SUBJECT: Case 20894: Substantive Amendments to an Existing Development Agreement for 5511 Bloomfield Street, Halifax

Application by WSP Canada Inc.

ATTACHMENT A: PROPOSED AMENDING DEVELOPMENT AGREEMENT

Schedule I.1

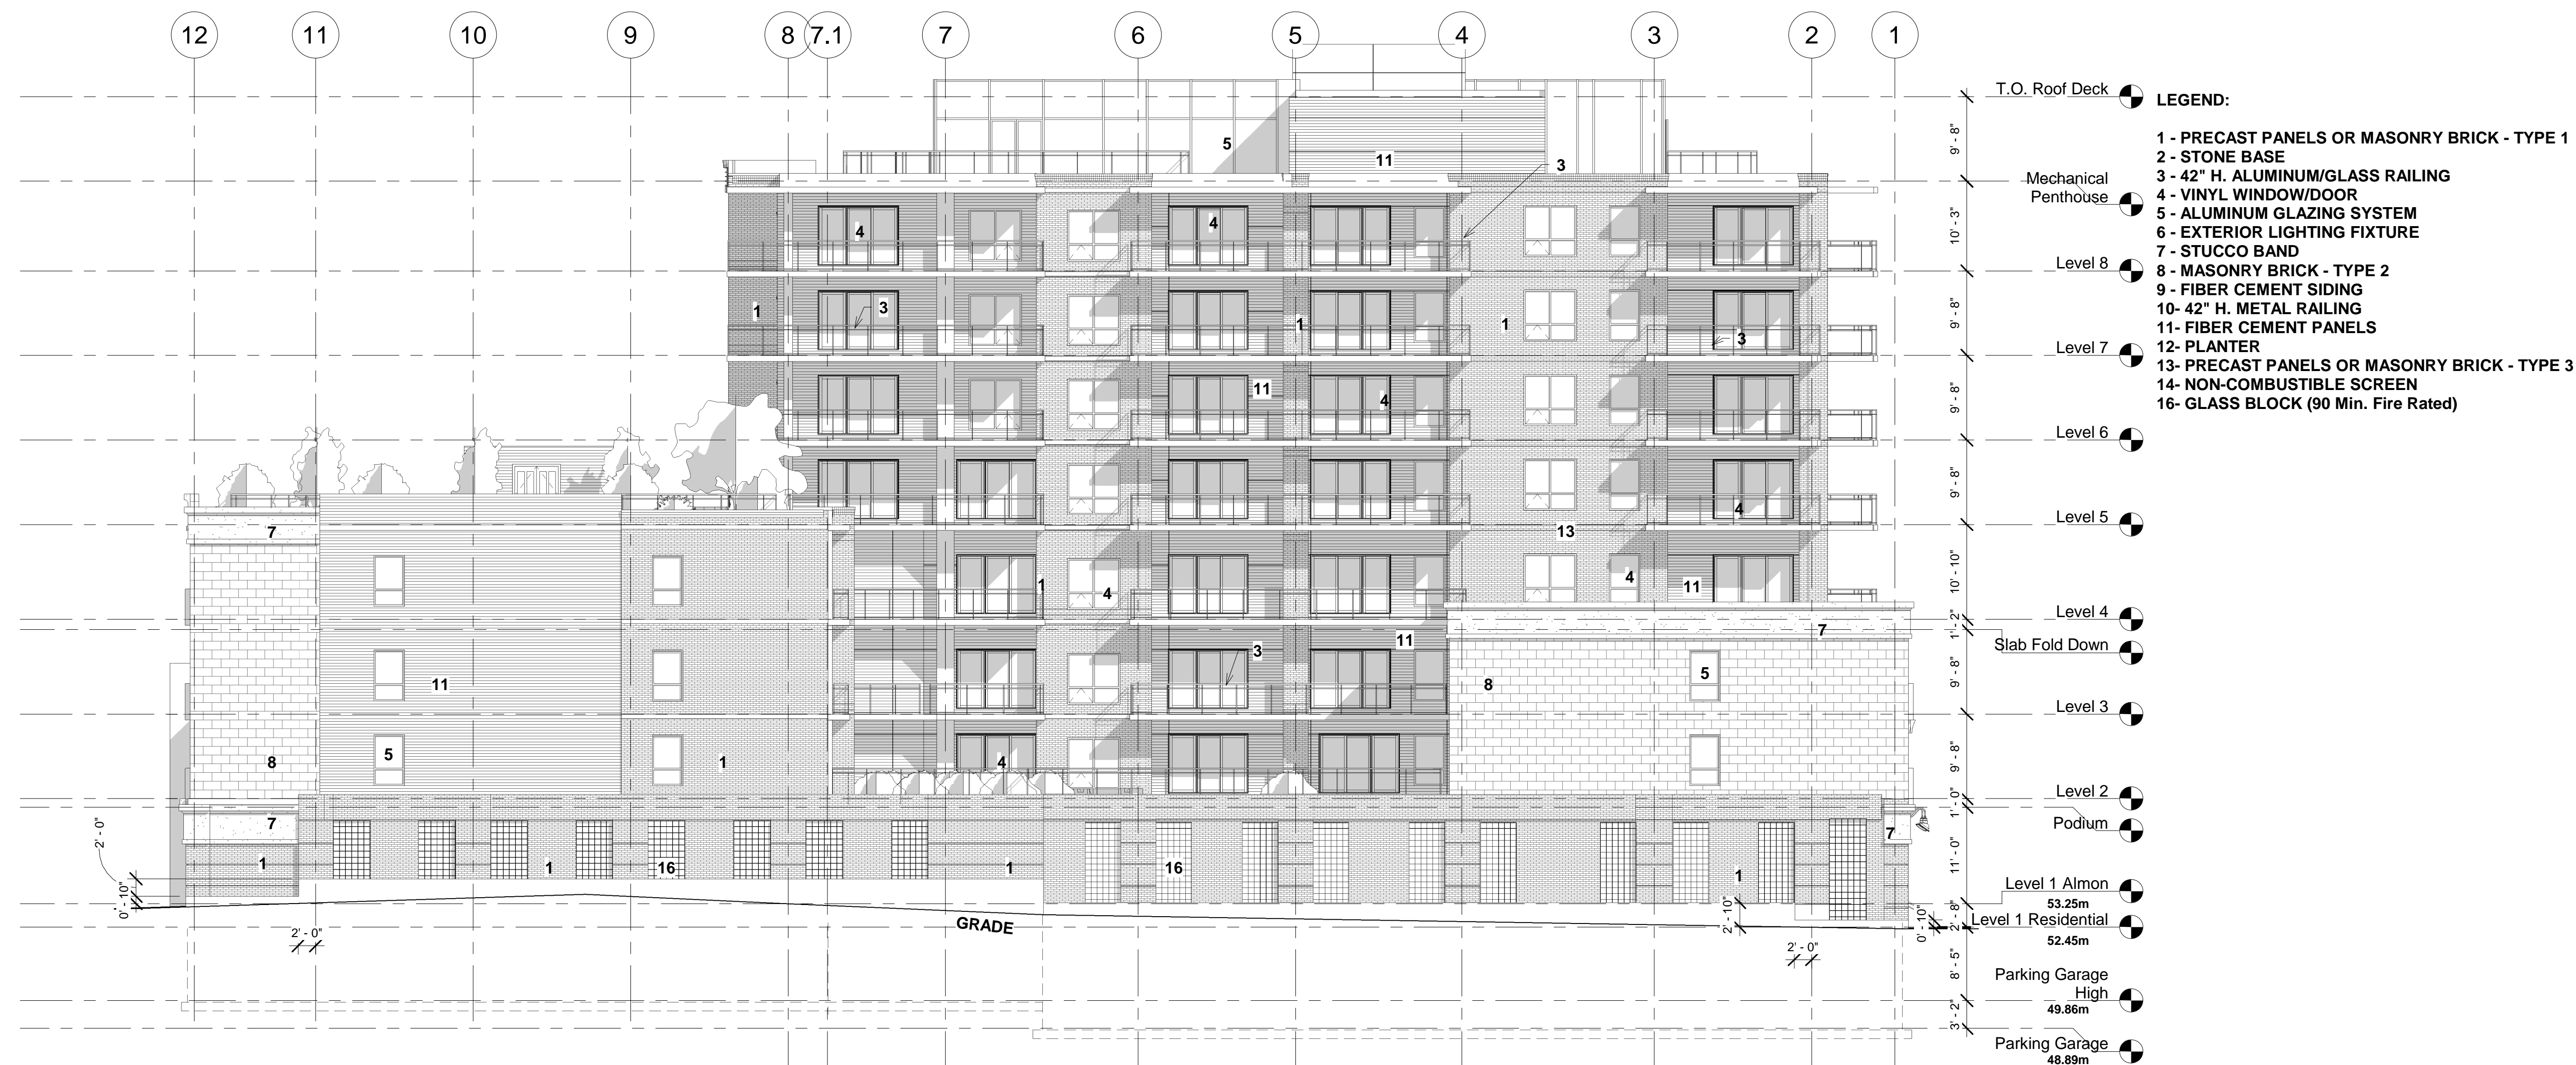
- h) deleting all references to "Schedule I" and replacing each with a reference to "Schedule I.1"
 - i) deleting all references to "Schedule J" and replacing each with a reference to "Schedule J.1"
